From: Jo Sunde <jo.sunde@woods.co.nz>
Sent: Wednesday, 27 November 2024 4:27 pm
To: Joy LaNauze
Cc: [REDACTED]
Subject: Heights Road Plan Change SMP - Revision per 22/11/24 meeting agreements

Sakti has put together quick reference guide below to show where the further information has been provided in the updated SMP to address HW's outstanding points:

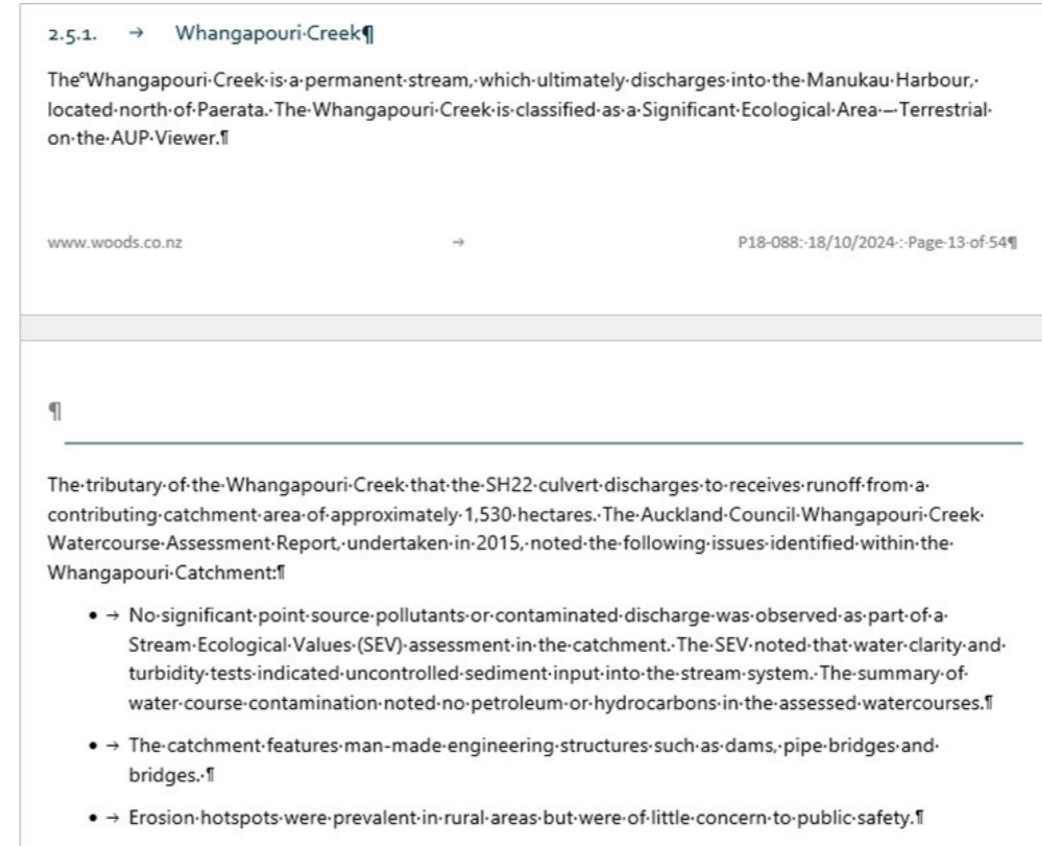
There is no information/assessment of the existing condition and needs (if any) of the immediate receiving environment (Whangapouri Creek). This information is needed to investigate whether there are known concerns which should guide the stormwater management approach on the site, in particular whether it is necessary to enforce the higher level of water quality requirements or whether the existing measures for water quality treatment are sufficient.

We request that you review the Whangapouri Creek Watercourse Assessment Report and Paerata Pukekohe Future Urban Zone Structure Plan Stormwater Management Plan and provide commentary in Section 2.5.1 on the current condition of the upper reaches of the Whangapouri Creek (as it is the immediate receiving environment). I have uploaded these for download here:

Section 2.5.1 amended.

Figure 14: Overall-proposed-stormwater-management-strategy

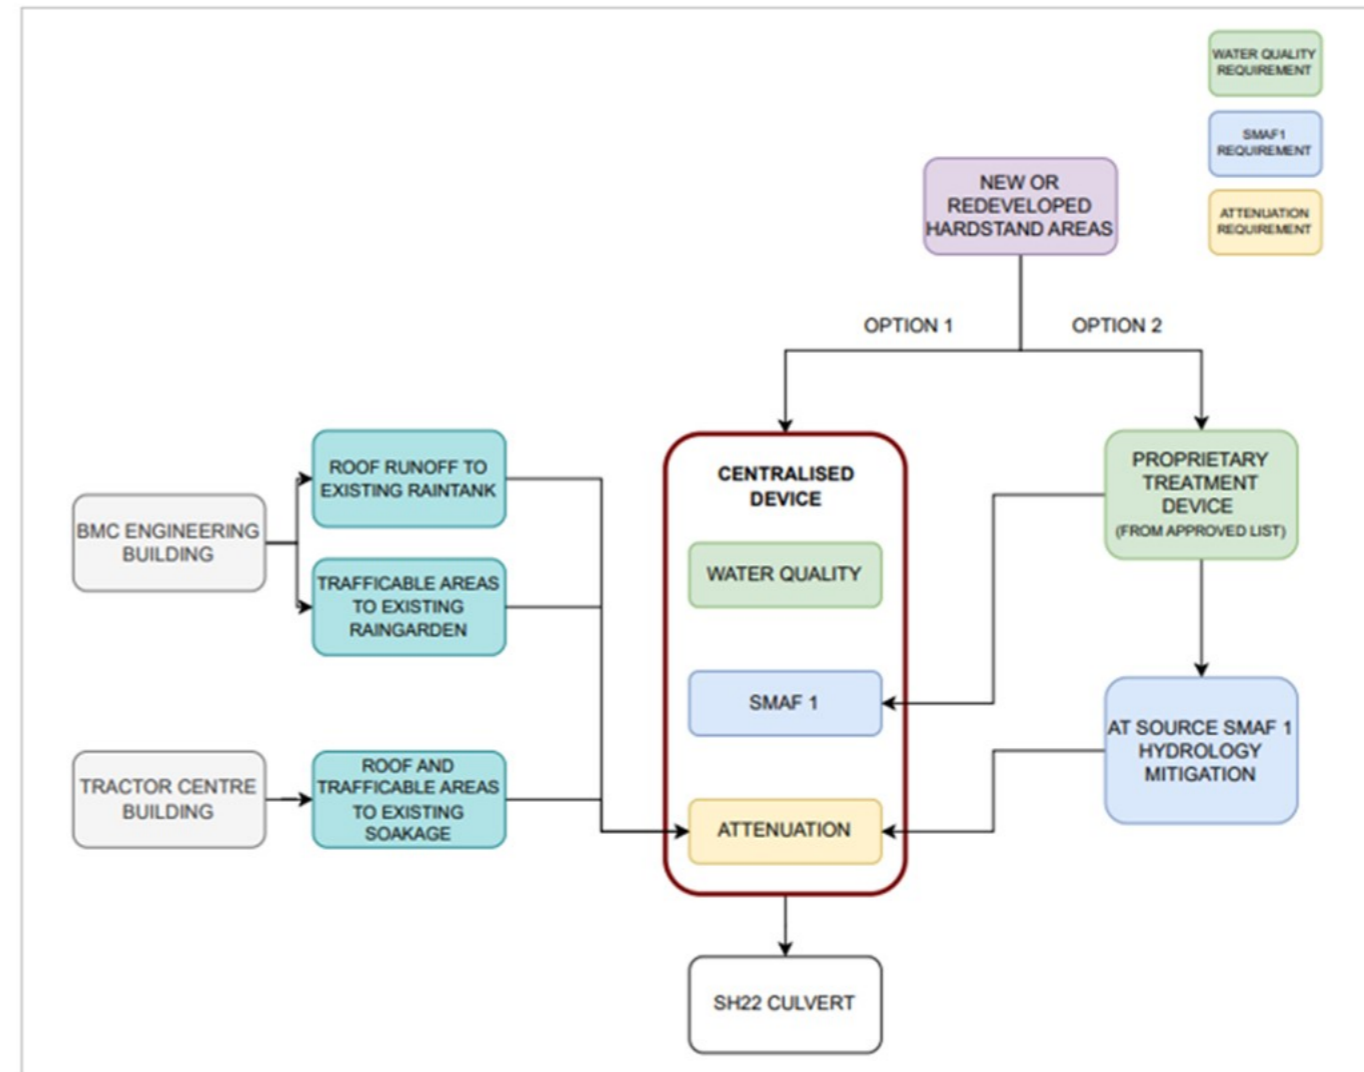
Seeking clarification around the text in Section 7.2.2 of the SMP and the flow chart in Figure 14 as this is somewhat misaligned, so it is unclear how water quality and retention and detention will be provided.

Clarification needed for stormwater management of developed or redeveloped surfaces. Pranil clarified this is either:

- 1) treated in a centralised proprietary treatment device with hydrological mitigation in a downstream stormwater management device OR
- 2) the centralised wetland is sized to provide treatment and hydrological mitigation for these surfaces.

Could you please provide this clarify in Section 7.2.1 and the flow diagram on Figure 14.

Figure 14 updated.

Figure 14 provides a schematic of the overall proposed stormwater management strategy for the PPC. The schematic shows all options presented in the SMP and highlights the recommended strategy.
